Model 114 Service Letter Index (Cont)

SERVICE LETTER NO. SL-114-1A

CABIN NOISE REDUCTION

Figure 1.

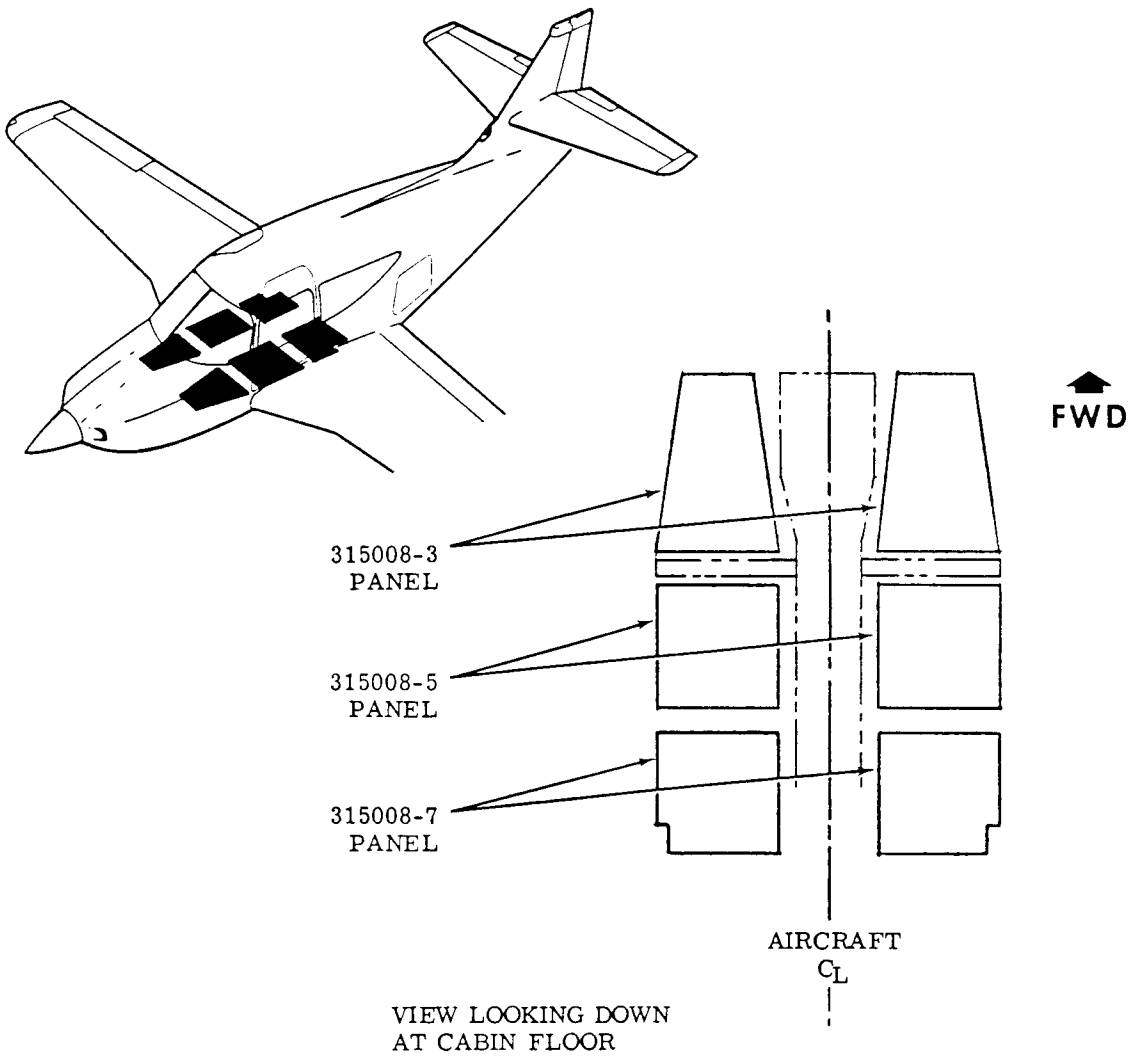
1. Sand all areas where noise reduction panels are to be installed with 400 grit sandpaper (see Figures 1 and 2.).
2. Wipe sanded area clean with Stoddard solvent or equivalent.
3. Install 315007-3 and -4 stiffeners and 315007-5 and -6 clips as shown in Figure 2.

Figure 2.

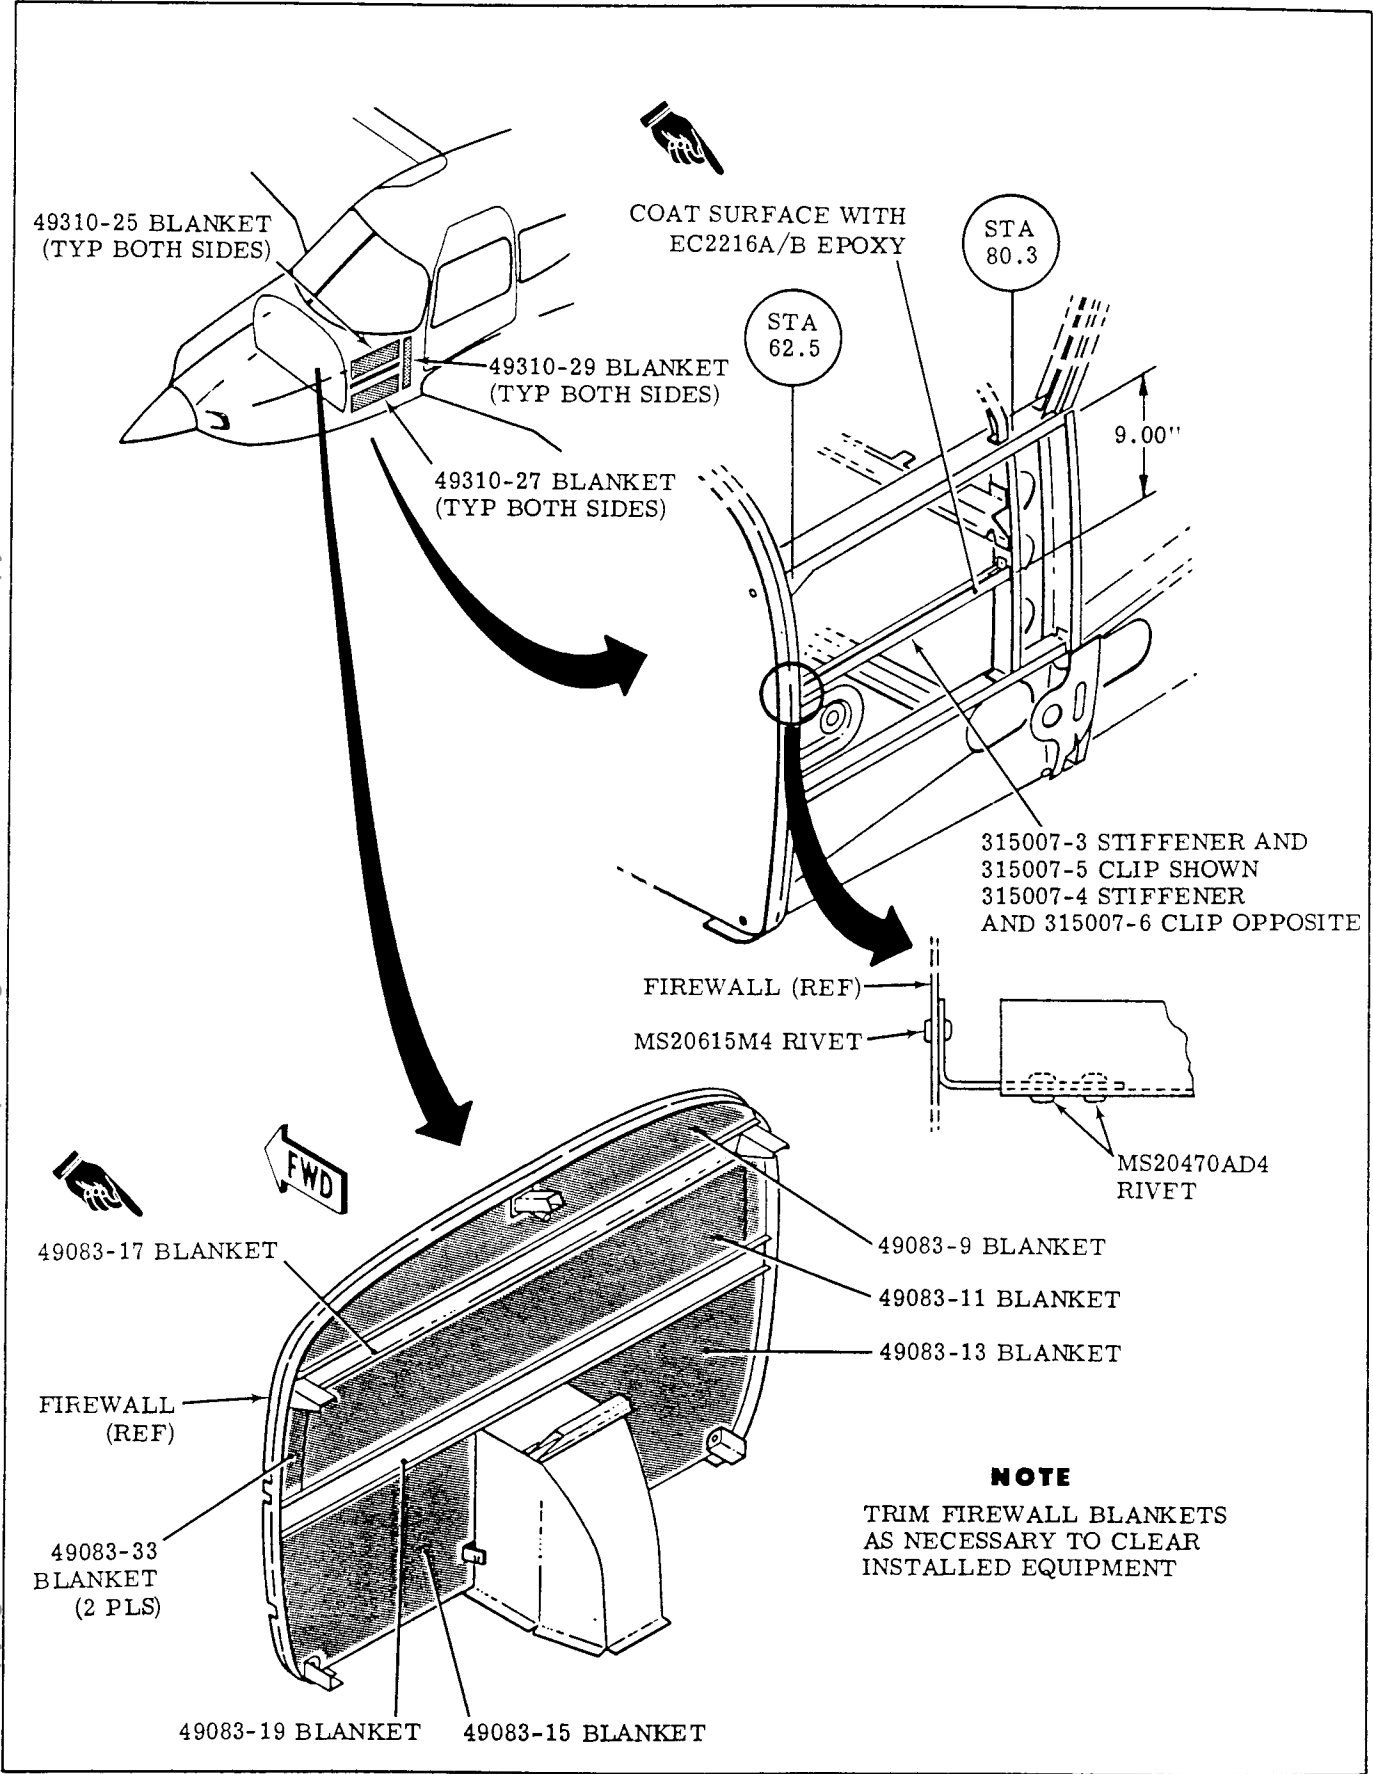
4. Cut and trim 49083 blankets as required to clear equipment installed on aft side of engine firewall (see Figure 2.).
5. Apply EC1403 adhesive to rubber side of trimmed blankets and attach to firewall.
6. Cut and trim 49310-25 and -27 blankets as required to install above and below stiffeners installed in step 3. above.
7. Apply EC1403 adhesive to trimmed blankets and attach to fuselage skin (see Figure 2.).
8. Install 49310-29 blankets by inserting blanket through airframe lightening holes.
9. Reclean floor area with Stoddard solvent or equivalent.
10. Immediately after cleaning floor area apply 2-part EC2216 A/B Epoxy to cleaned area.
11. Press 315008 panels in place and utilize weights to hold panels against floor surface until epoxy has cured.

Figure 1.

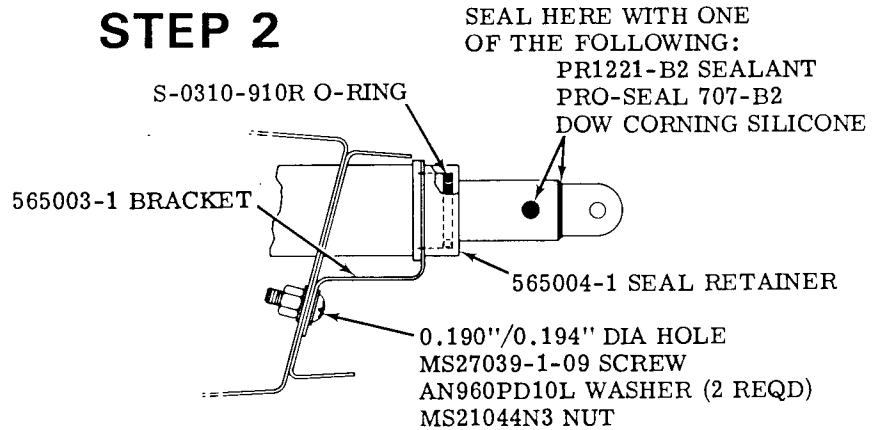
4. Add a bead of PR1221-B2 sealant, or Pro-Seal 707-B2, or Dow Corning Silicone around elevator trim tab actuator as shown in Figure 1.
5. Install S-0310-910R O-ring, 565004-1 seal retainer and 565003-1 bracket on elevator trim tab actuator, drill a 0.192 (± 0.002) inch diameter hole through bracket and elevator spar and install MS27039-1-09 screw, AN960PD10L washer (2 places) and MS21044N3 nut (see Figure 1.).
6. Cover clevis joint and both ends of roll pin with either PR1221-B2 sealant, Pro-Seal 707-B2 or Dow Corning Silicone (see Figure 1.).

Figure 1.

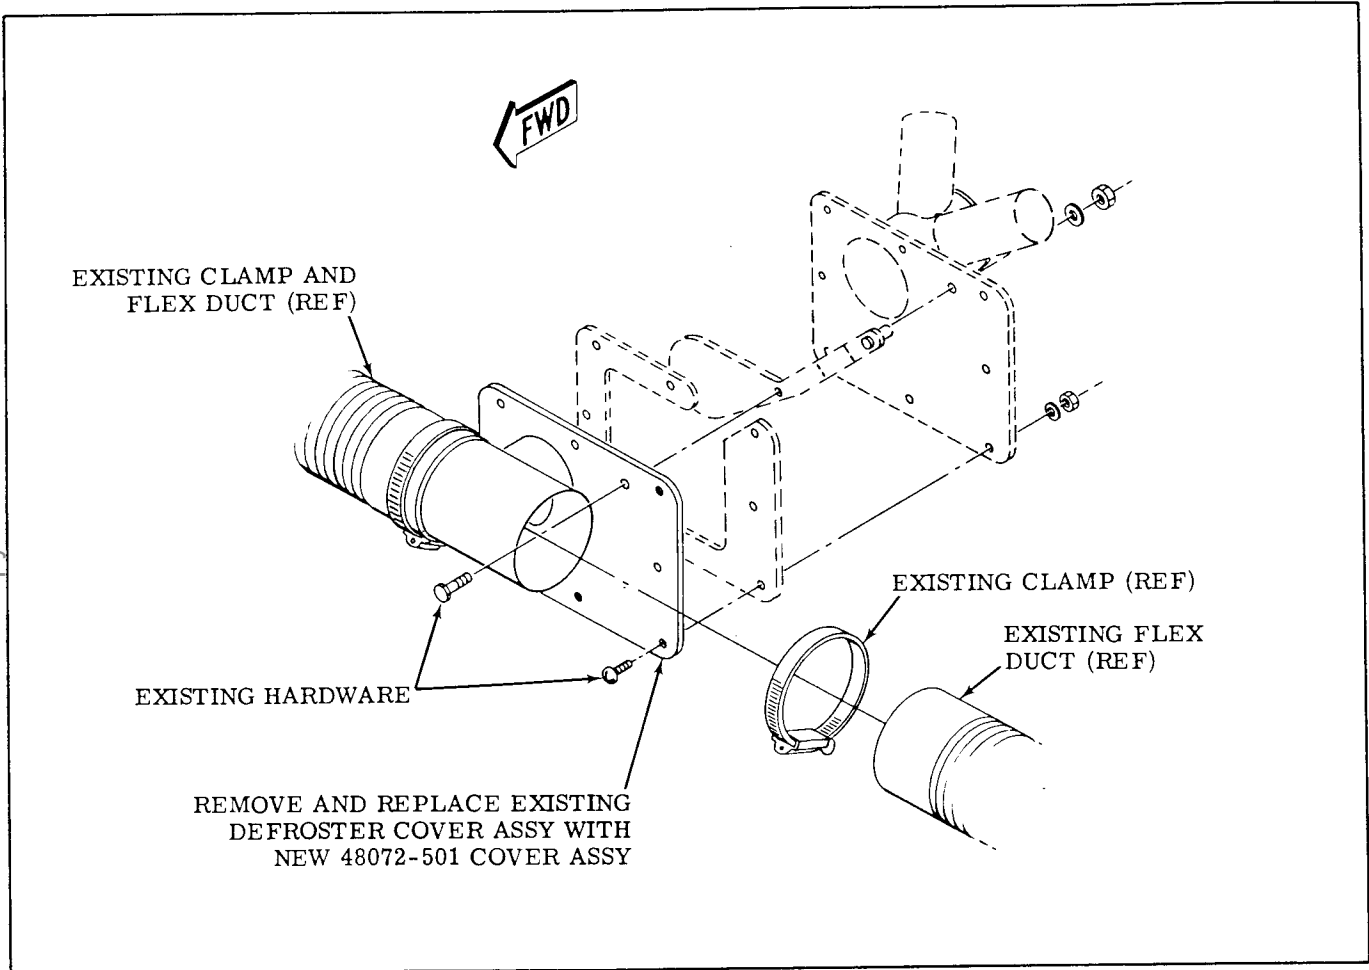
1. Remove upper engine cowling.
2. Disconnect flex ducts from defroster valve cover.
3. Remove and discard existing defroster valve cover assembly (see Figure 1.).
4. Install 48072-501 defroster valve cover assembly using existing hardware and seal around outer perimeter of cover assembly with Coast Pro-Seal 700, MIL-S-38249, Type I (see Figure 1.).
5. Reconnect existing flex ducts to new defroster valve cover assembly using existing clamps.
6. Reinstall upper engine cowling.

Figure 1.

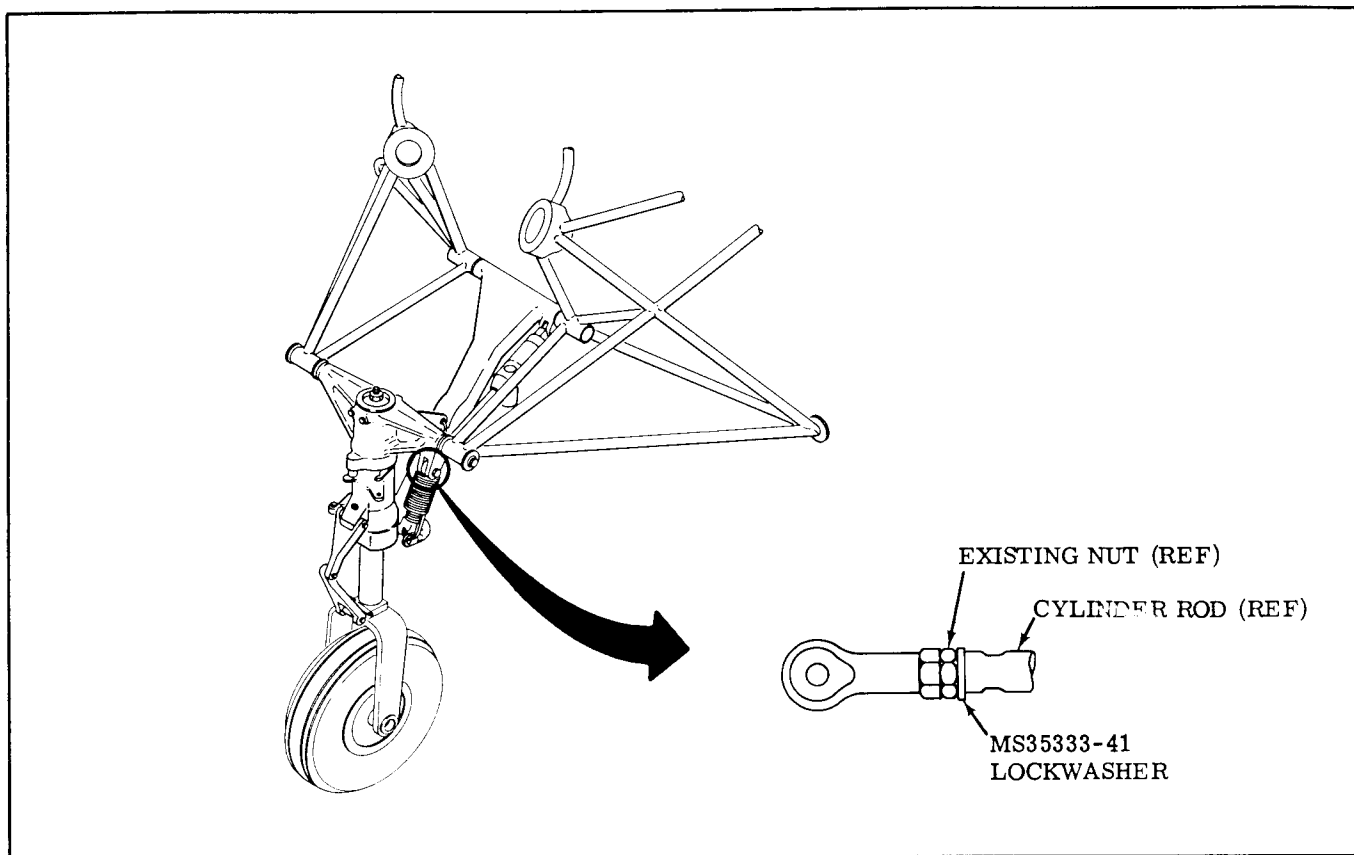
1. Jack airplane as outlined in the Airplane Maintenance Manual, Section II.
2. Disconnect nose landing gear retract cylinder at landing gear trunnion.
3. Loosen rod end nut and remove rod end.
4. Install MS35333-41 lockwasher and existing rod end on nose landing gear retract cylinder and run nut and rod end all the way down on threads of retract cylinder (see Figure 1.).
5. Check drag brace assembly at knuckle area to assure that drag brace is resting on stop.

Figure 2.

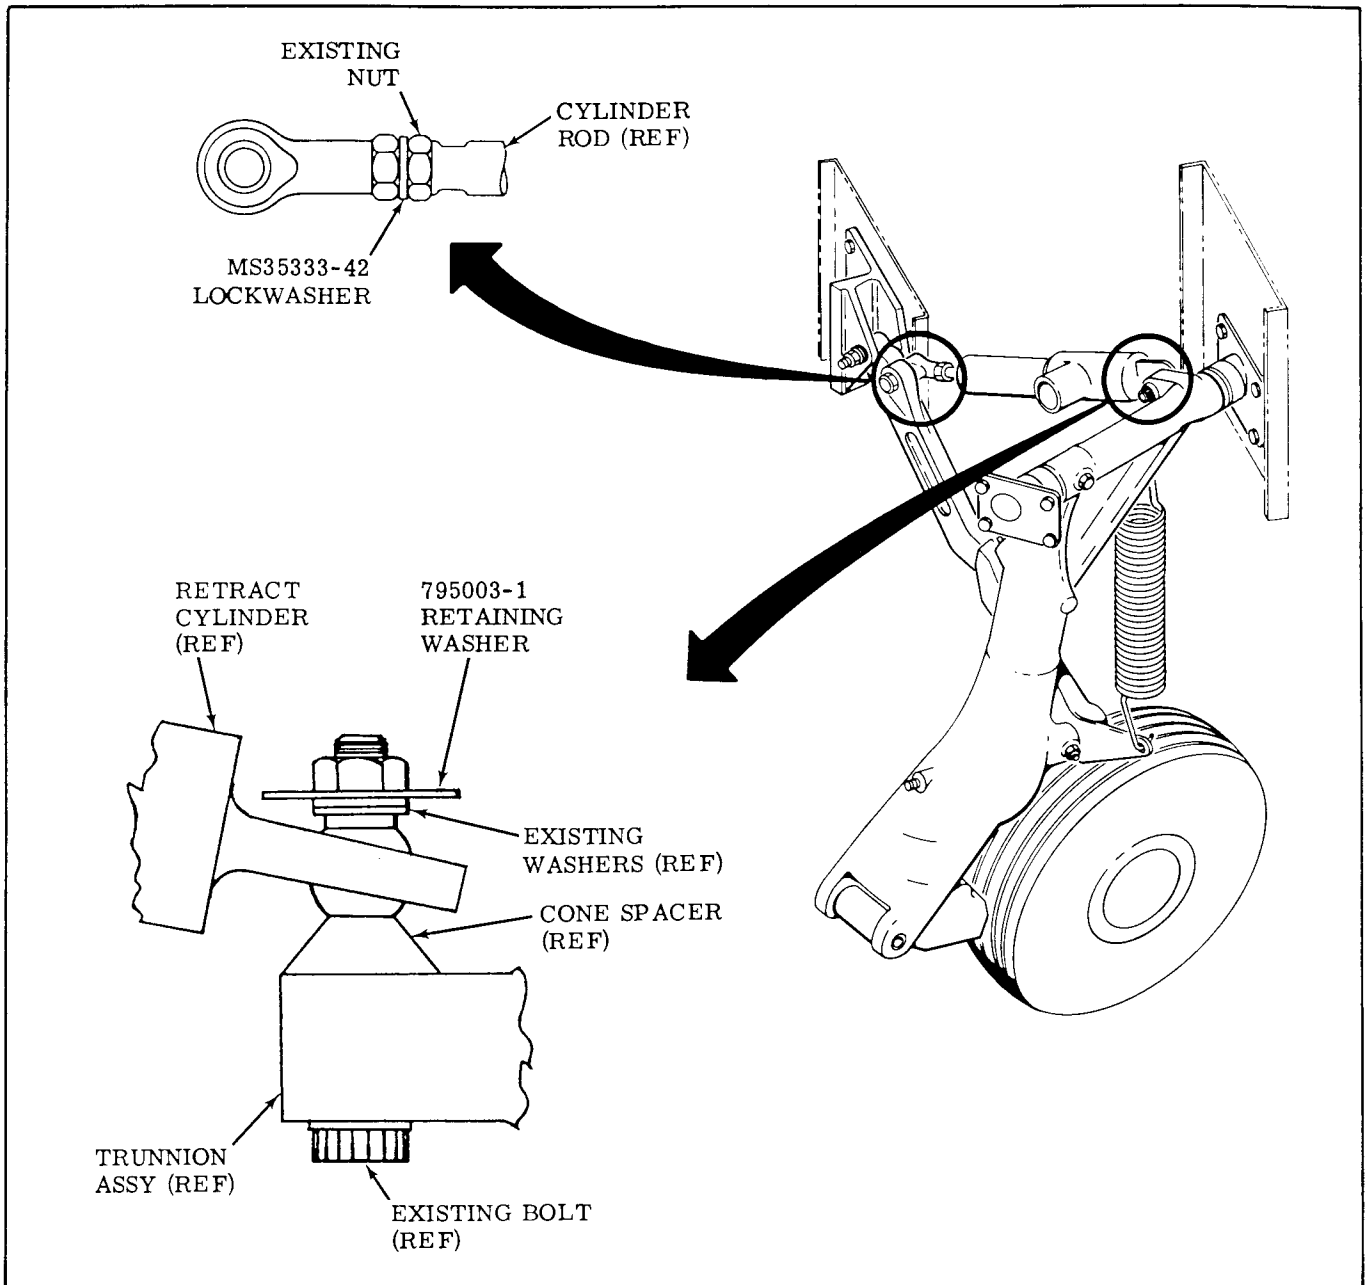
8. Collapse nose landing gear as necessary to gain access to rod end nut and torque nut 60 to 85 inch-pounds against cylinder rod and lockwasher while holding cylinder rod securely.
9. Remove bolts attaching the inboard end of the left and right main landing gear retract cylinder to the side brace assemblies.
10. Loosen rod end nut and remove rod end.
11. Install MS35333-42 lockwasher and existing rod end on left and right main landing gear retract cylinder (see Figure 2.).

Figure 3.

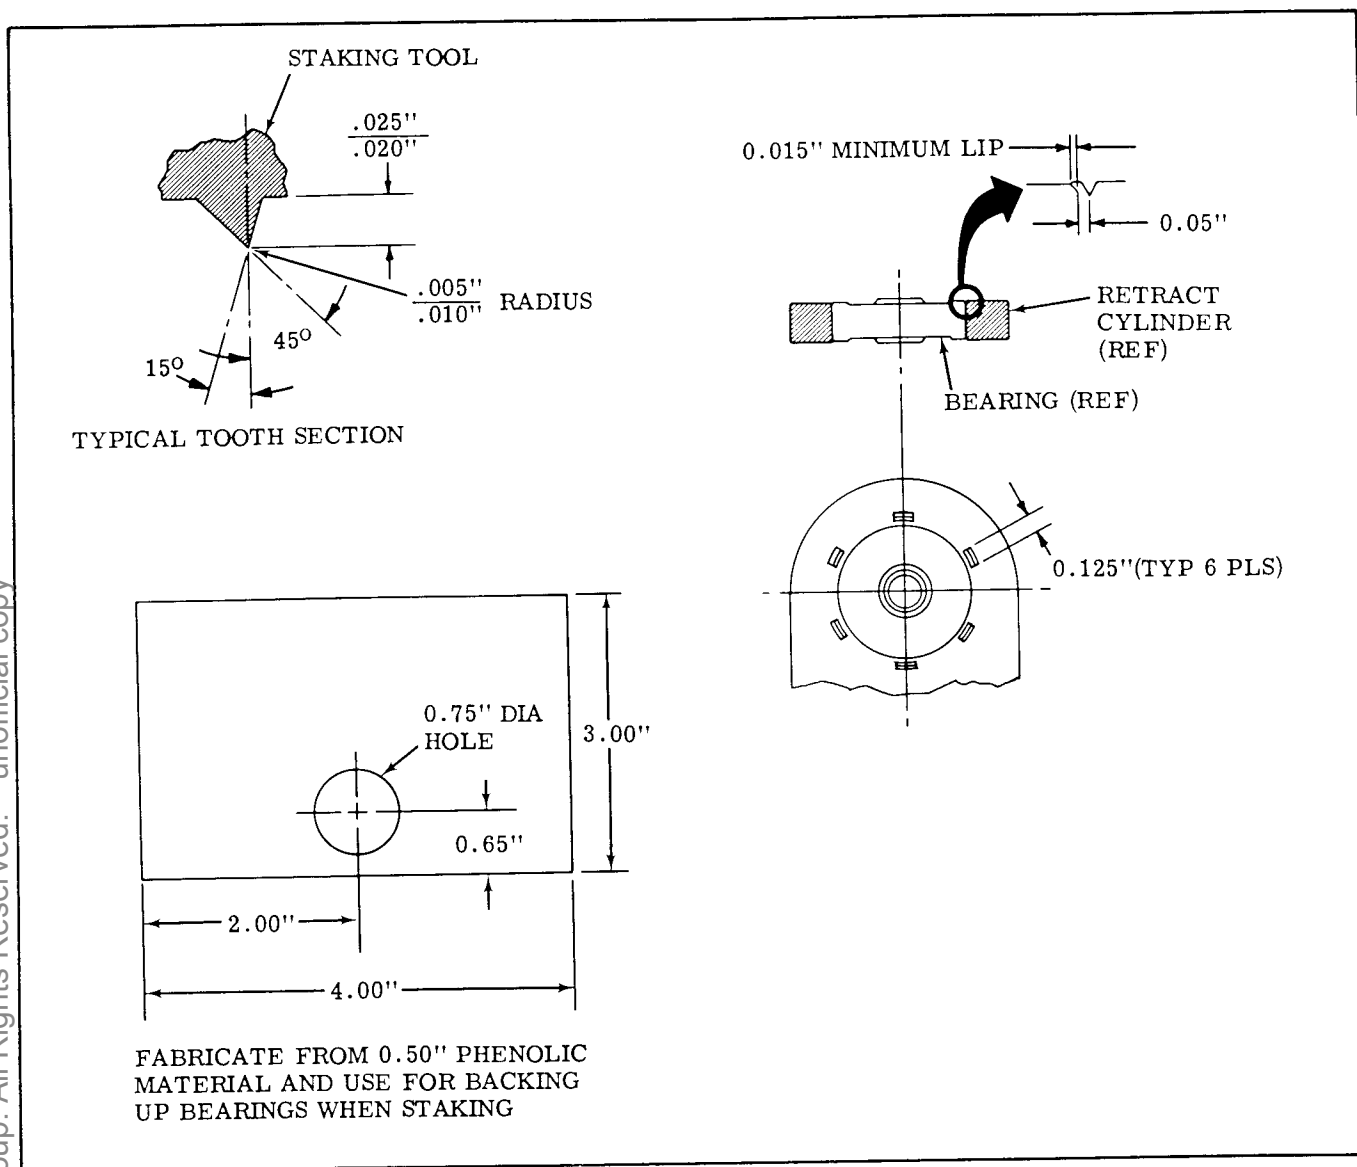
- b. Inspect cylinder end plug bearings to assure that the bearings are properly staked as shown in Figure 3.

- c. If bearings are properly staked, proceed to step 12.e.
- d. If bearings are not properly staked, hand stake bearings six (6) equal spaces around bearing (see Figure 3.) using a staking tool that conforms to dimensions shown in Figure 3.

Fabricate a block from 1/2-inch phenolic material for backing up bearing when staking (see Figure 3.).
